STAFF RECOMMENDATION 1503 Clayton Avenue June 19, 2019

Application: New Construction-Addition; Partial Demolition
District: Belmont-Hillsboro Neighborhood Conservation Zoning Overlay
Council District: 17
Map and Parcel Number: 11708017900
Applicant: Tarl LaRocco
Project Lead: Melissa Sajid, melissa.sajid@nashville.gov

Description of Project: The application is to revise a previously approved addition.

Figure 1: 1503 Clayton Avenue

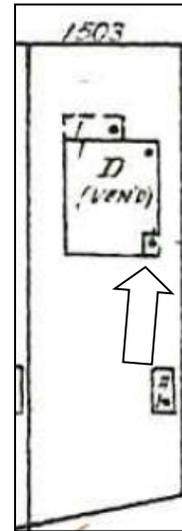
Background: The house at 1503 Clayton Avenue was constructed c. 1925 and contributes to the character of the Belmont-Hillsboro Neighborhood Conservation Zoning Overlay.

1503 CLAYTON AVENUE
REAR ELEVATION

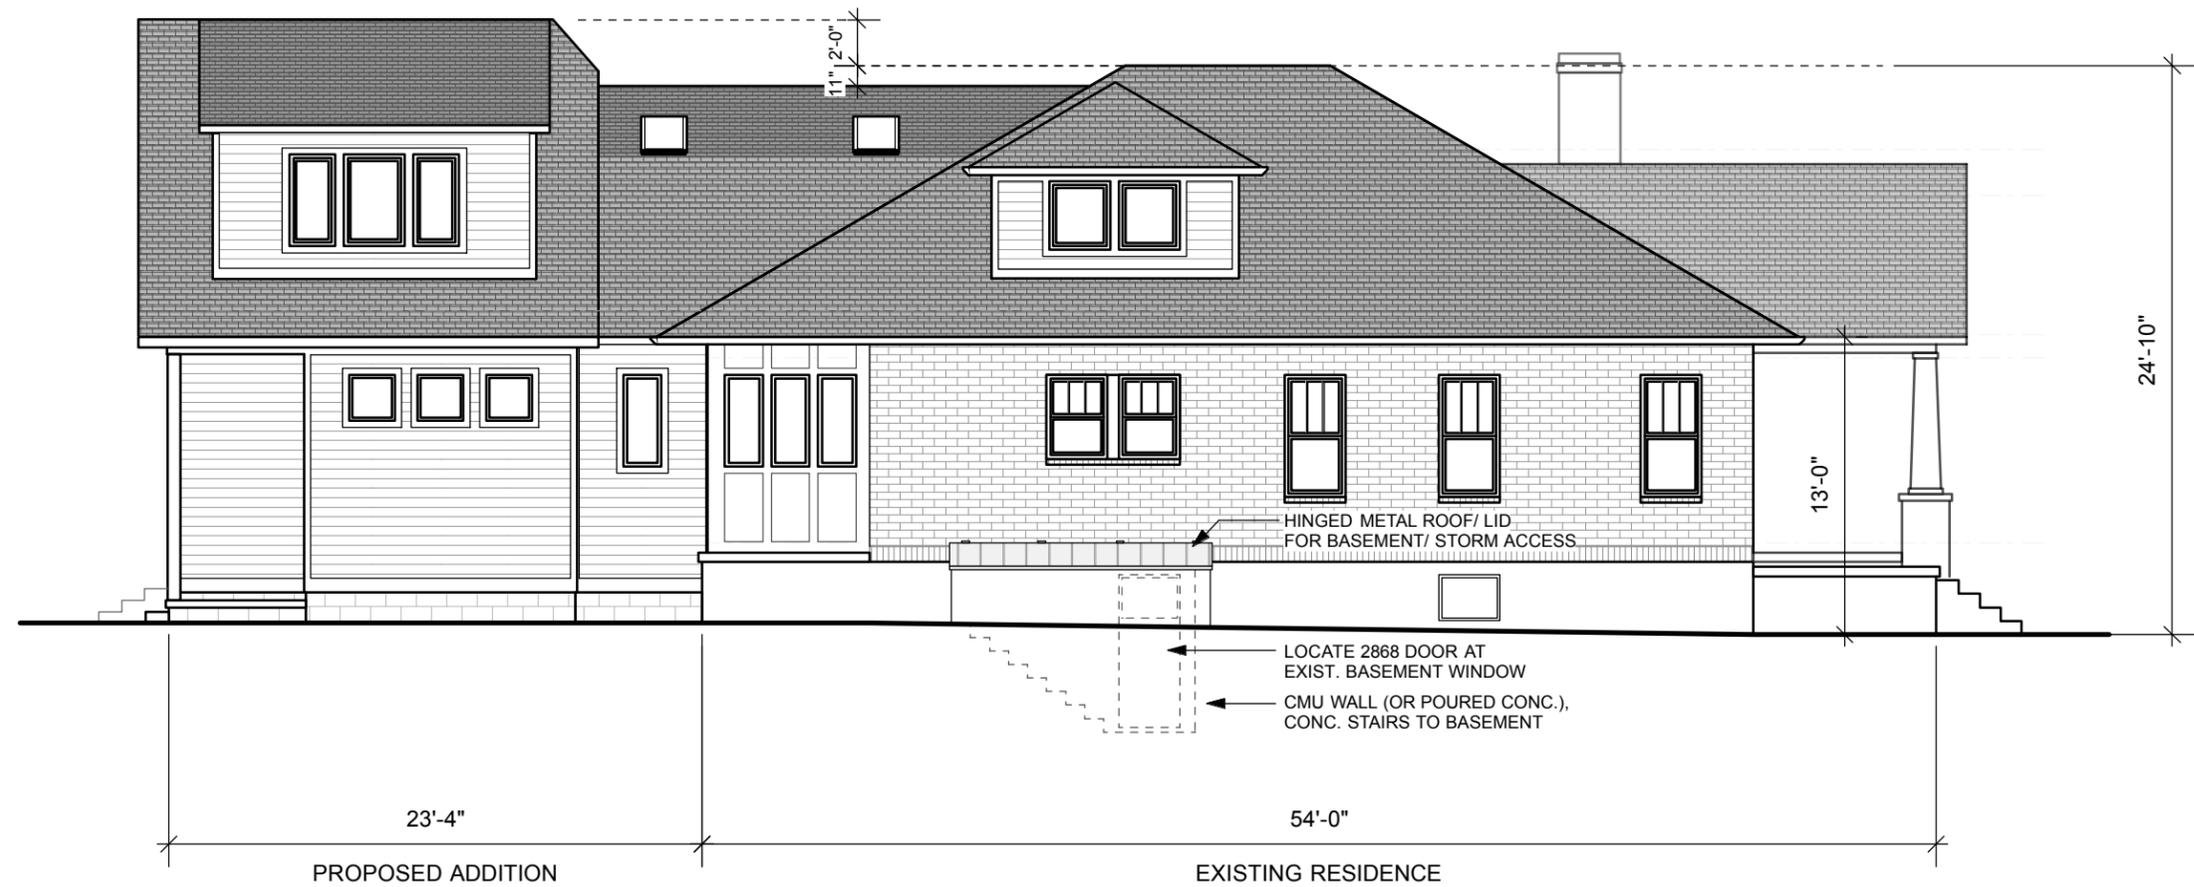
The proposed addition is taller than the historic house. The addition ties in ten inches (10") below the ridge of the existing house and then goes back approximately twenty-one feet (21') before rising two feet (2') taller than the ridge of the historic house. The additional height is located forty-nine feet (49') behind the front wall of the historic house. The addition meets the design guidelines for when a taller addition can be appropriate since the addition is no more than two feet (2') taller than the historic house and the additional height is located at least forty feet (40') behind the front wall of the house.

Roof form: The historic house has a hipped roof. The proposed addition incorporates a gambrel roof form where the addition ties into the historic house. The part of the addition that is taller than the historic house has a clipped rear gable form with shed dormers on both sides that are set in two feet (2') from the wall below. The project also includes side dormers on the historic house. The proposed side dormers are appropriately scaled and incorporate a hipped roof form with a pitch similar to the pitch of the historic house. Both proposed side dormers sit in two feet (2') from the wall below as required by the design guidelines. Staff finds that the roof forms of the rear addition and side dormer additions are compatible with the roof form of the historic house.

1503 CLAYTON AVENUE
SITE PLAN

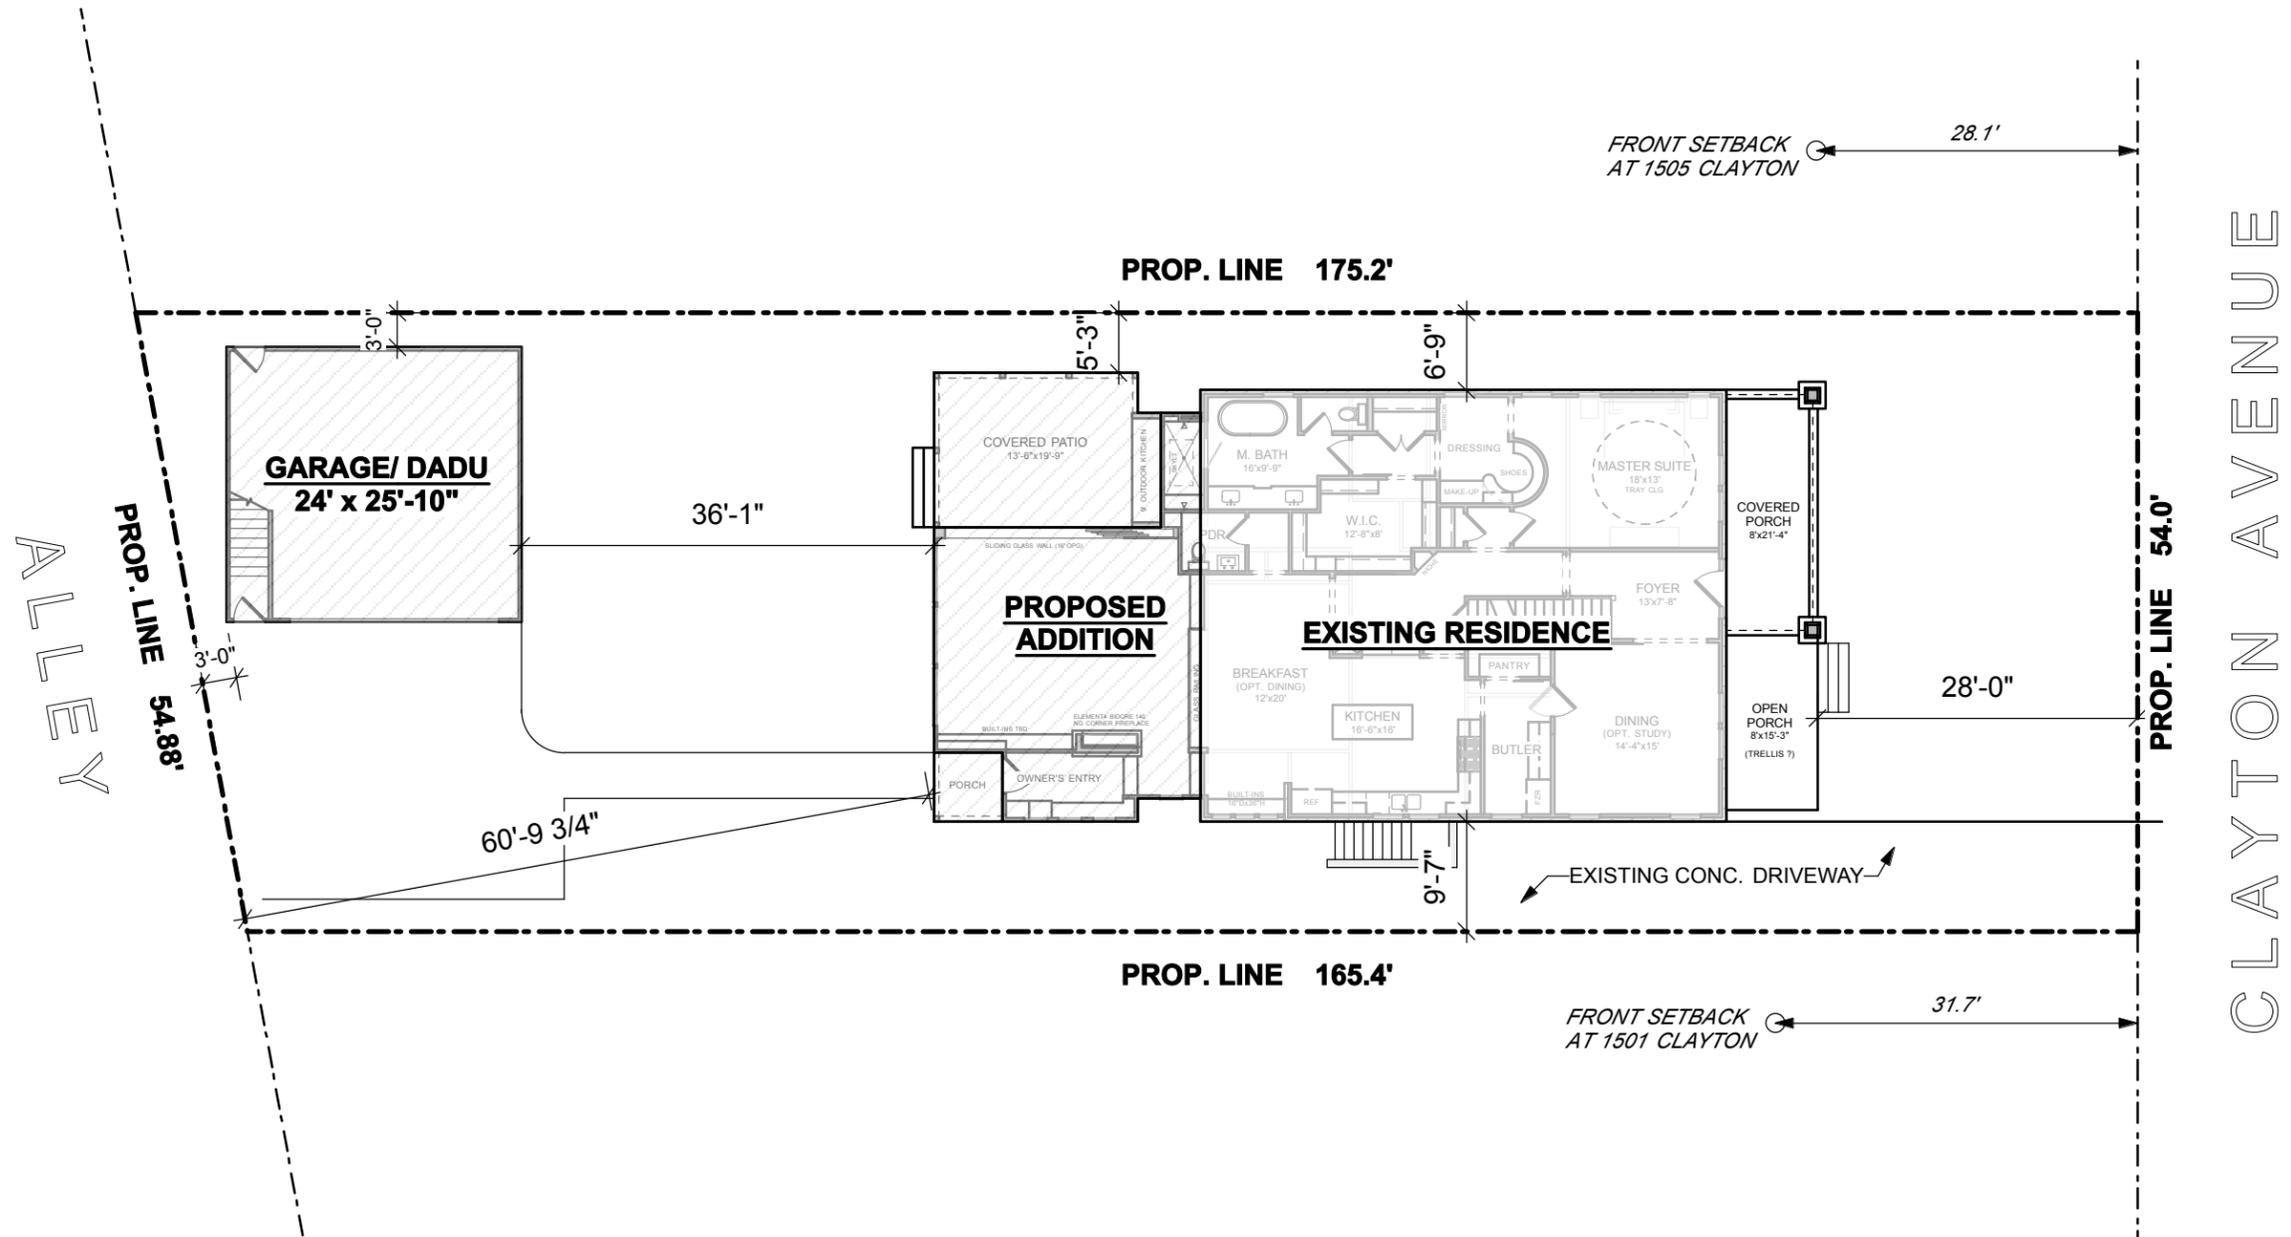
Setback & Rhythm of Spacing: The project meets all base zoning requirements. The addition will have a left side setback of approximately nine feet (9') and a right side

setback of five feet, three inches (5'-3"). The rear of the addition will be approximately sixty feet, nine inches (60' 9") from the rear property line. The project meets section II.B.1.c for setback and rhythm of spacing for new construction.

Appurtenances & Utilities: No changes to the site's appurtenances were indicated on the drawings. The location of the HVAC and other utilities was also not noted. Staff asks that the HVAC be located on the rear façade, or on a side façade beyond the midpoint of the house if relocated. The project meets section II.B.1.h for utilities.

1. Staff approve the final foundation material, secondary cladding material, roof color, windows, doors, porch columns, porch steps, and porch floor, prior to purchase and installation; and,
2. The HVAC shall be located behind the house or on either side, beyond the mid-point of the house if relocated. Utility meters shall be located on the sides or rear of the building. Alternative mechanical and utility locations must be approved prior to an administrative sign-off on the building permit(s).
